WANNER™ HYDRA-CELL® PRO

Technical Bulletin TB0090

SUBJECT: Updated T100 & Q155 Connecting Rod Cap Bolt Torque Specification

Pump Models Affected: All T100 & Q155 Wanner™ Hydra-Cell® pump models.
– All series, all pressure ratings.

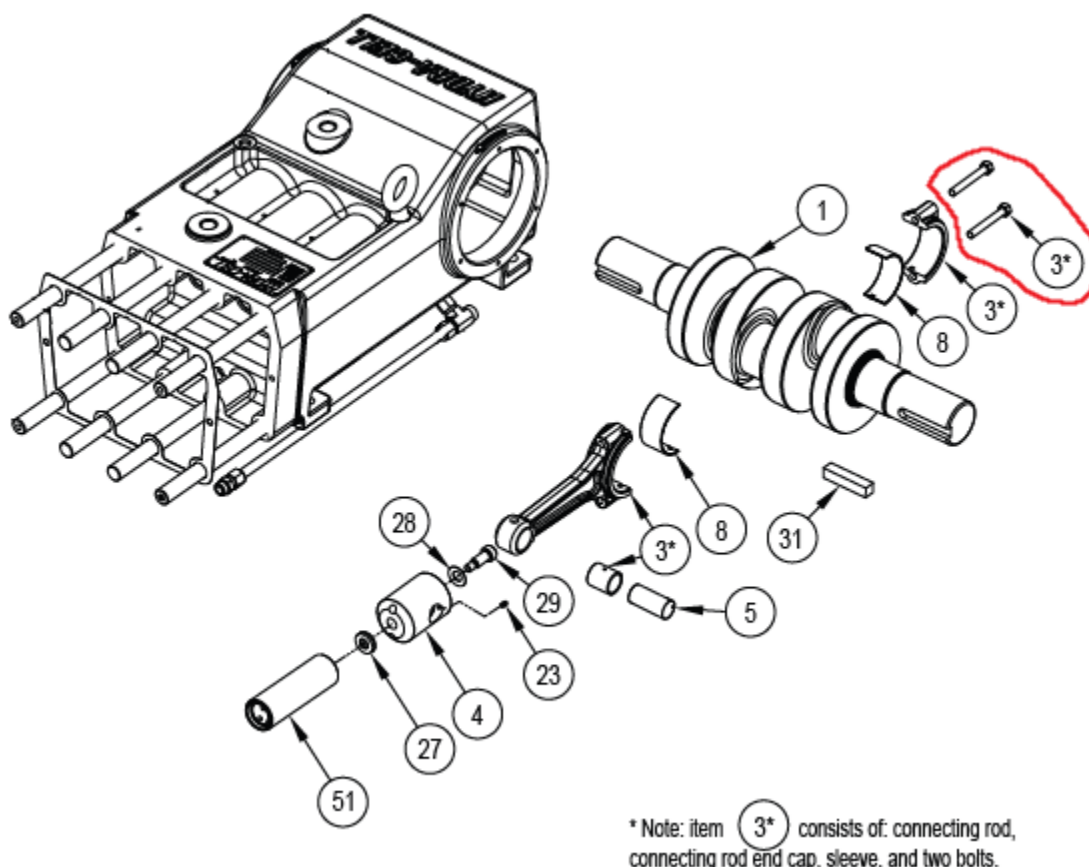
To reduce the risk of breaking the 177-063 connecting rod cap bolt (part of the 177-003-02 connecting rod subassembly) during installation, we are lowering the torque specification from 100 ft-lbs (136 N-m) to **75 ft-lbs (102 N-m)**.
